THE GATEWAY SUBDIVISION

Engineering Comments: FINAL PLAT COMMENTS (should be addressed prior to submitting the FINAL PLAT for review and/or signature by the City Engineer):

APPLICATION NUMBER 4 DATE February 3, 2021

DETAIL SITE PLAN

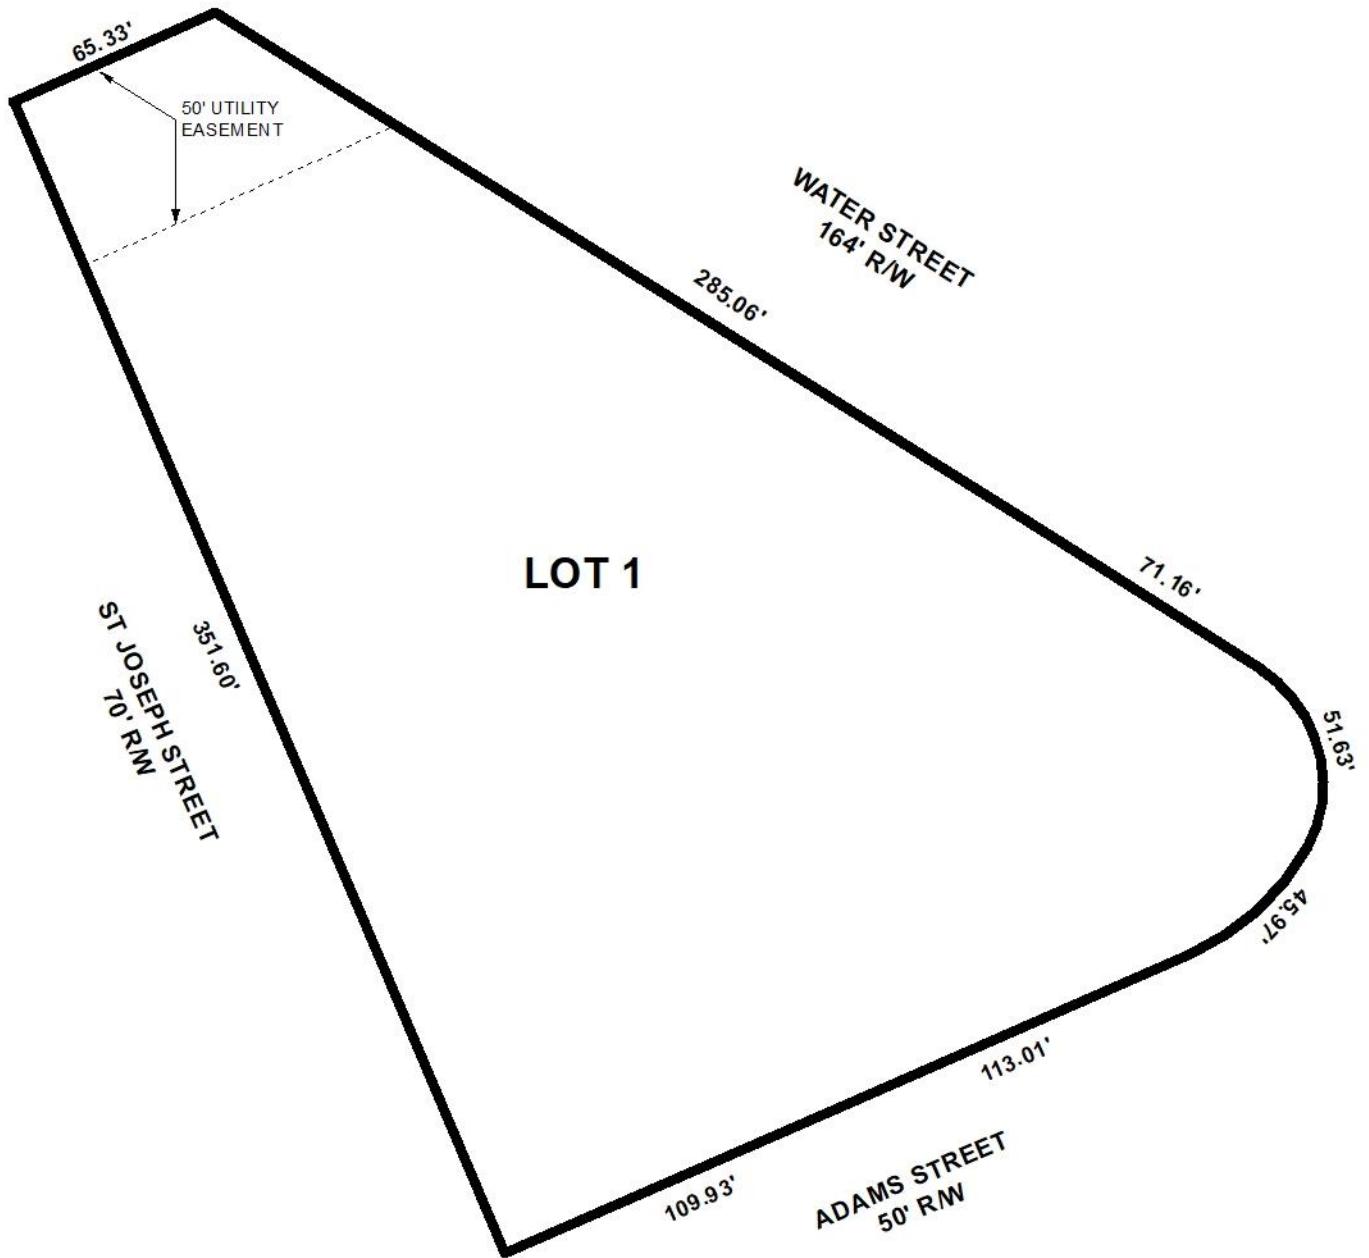
The site has frontage on three streets: North Water Street, a major street, Saint Joseph Street, a minor street, and Adams Street, a minor street. All of the streets have adequate right-of-way, thus no dedication will be required.

Sections V.B.16. and V.D.6. of the Subdivision Regulations may require the provision of a corner radius. As this site is located within the downtown area, compliance with these requirements should be coordinated with the City Engineer.

The preliminary plat does not depict the 25-foot minimum building setback line required by Section V.D.9. of the Subdivision Regulations. Due to the site's location within the Downtown Development District (DDD), a minimum setback of zero (0) feet is allowed, and a maximum setback of twelve (12) feet is allowed. The plat should be revised to depict or note the minimum and maximum setbacks allowed per the DDD, and the Subdivision Regulation requirement should be waived.

Section 64-3.I.8.(b)(3) of the DDD section of the Zoning Ordinance limits the property width along a primary frontage street in a T-5.1 Sub-district to 180 feet maximum. St. Joseph Street, is the abutting primary frontage "A" street (Water Street and Adams Street are secondary "B" streets), and the proposed lot will have approximately 351 feet of frontage. As this lot width maximum is contained within the Zoning Ordinance, the Planning Commission does not have the authority to waive this requirement. Therefore, the applicant must submit a variance request to the Board of Zoning Adjustment for consideration. Given that the subdivision request is to accommodate an existing developed property that is undergoing renovation, a hardship may exist with the property.

A utility easement is depicted along the north portion of the property. The note on the plat should be revised to state that no structure may be constructed or placed within any easement without the permission of the easement holder, if applicable.

Finally, notes on the plat should be revised to reflect changes to the standard Fire comments.

- 1) Application to the Board of Zoning Adjustment to request a waiver of Section 64-3.I.8.(b)(3) of the DDD section of the Zoning Ordinance regarding maximum property width along a primary frontage “A” street, and successful completion of this process prior to the signing of the Final Plat;

- 2) Revision of the plat to depict and label the minimum and maximum allowed setbacks (*minimum setback of zero (0) feet and a maximum setback of twelve (12) feet*);

- 3) Coordination with the City Engineer to determine if the dedication of a corner radius is required, in accordance with Sections V.B.16. and V.D.6. of the Subdivision Regulations;

- 4) Revision of the plat to reflect any changes to lot area required by corner radius dedication, if any;
- 5) Revision of the note on the Final Plat regarding easements to state that “*no structure may be constructed or placed within any easement without the permission of the easement holder*.”
